Permit Application Review Report
Date: 2/18/2026

Project Name: Kurvers Residence Home Build

Project PAN: P-26-006

Project Purpose: construction of a new single-family home

Figure 3: Soil and Erosion Control

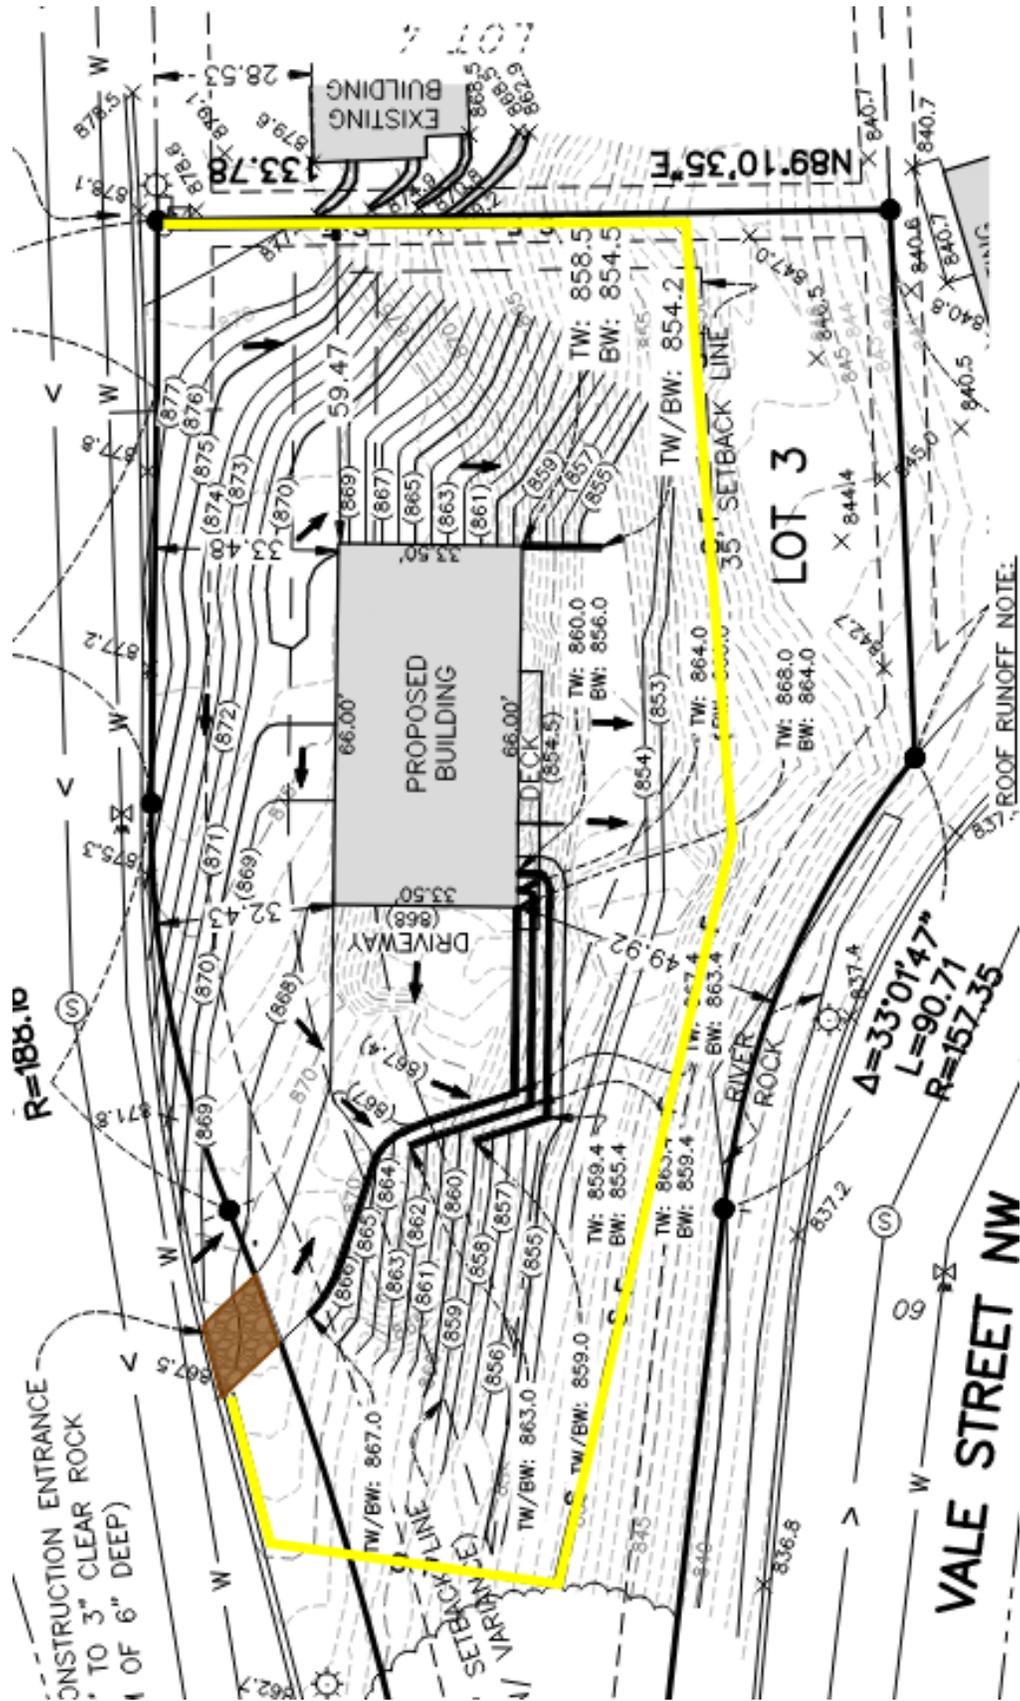
1. Updated the erosion and sediment control plan to include the following:
 - a. a note that portable toilets should be secured to prevent tipping.
 - b. standard details for erosion control devices.

The proposed project drains to Lower Coon Creek. The soil affected by the project includes Hayden fine sandy loam and has a soil erodibility factor of 0.15 or greater. Disturbed areas are proposed to be stabilized within 24 hours, as required. The proposed erosion and sediment control plan includes perimeter control, inlet protection, stabilized construction entrance, and street sweeping. The erosion control plan does not meet District requirements because standard details have not been provided for erosion and sediment control devices and portable toilets are not proposed to be secured. The site does not require an NPDES permit. See attached Figure 3: Soils and Erosion Control.
